# PREVOST

## WARRANTY BULLETIN

**WB23-11**

DATE :	April 2023	SECTION :	06 ELECTRICAL
EXPIRATION:	April 2025		
SUBJECT :	<b>HEADLIGHTS POWER SUPPLY</b>

## PART 1 : MODULE RECONNECTION

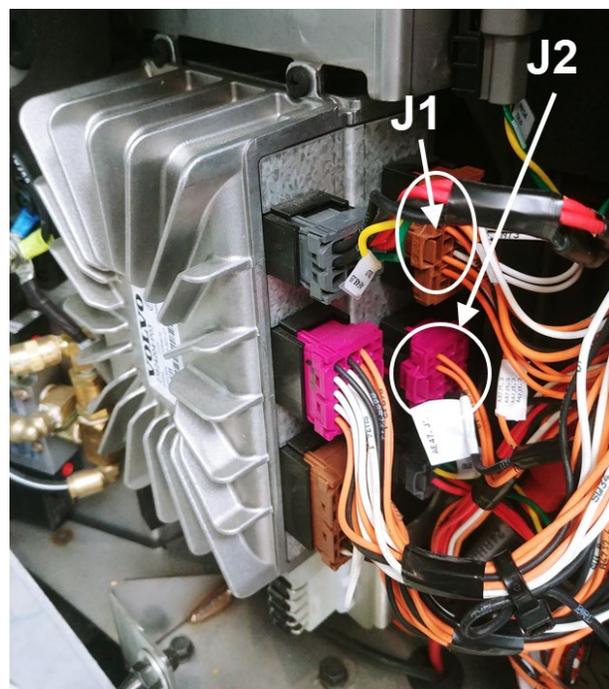
The vehicles affected by this bulletin require an update of the multiplex program (06100191.P01 for H3-45 and 06100192.P01 for H3-45 VIP) due to an intermittent power supply problem affecting the front left headlight in high beam position.

A wire reconnection at the A47 module is also necessary before the new program can be uploaded to the vehicle.

1. Remove the entrance electrical compartment panel.

- Unclip the lower part of the panel first.
- Slightly tilt the panel and disengage the upper panel hooks.
- Disconnect the panel harness.

2. Locate the faulty connection.

- Locate the **A47** I/OB module in the compartment as shown.
- On the side of the module, locate the **J1** and **J2** connectors.

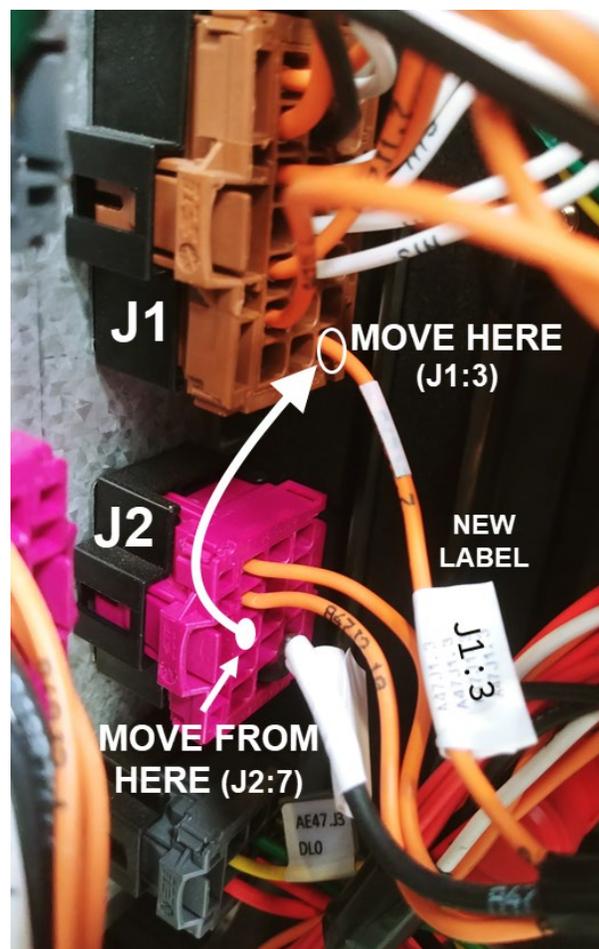
3. Reconnect the faulty wire.

- Locate wire **J2:7** (J2 middle connector)
- Disconnect J2 connector (see note for correct removal procedure)
- Remove the **J2:7** wire using extractor tool **568103** (see note for correct removal procedure).
- Put a label on the wire indicating that it will now be named **J1:3**.
- Reconnect **J2:7** wire into **J1:3** cavity of the J1 (top) connector.
- Reconnect the J2 connector.
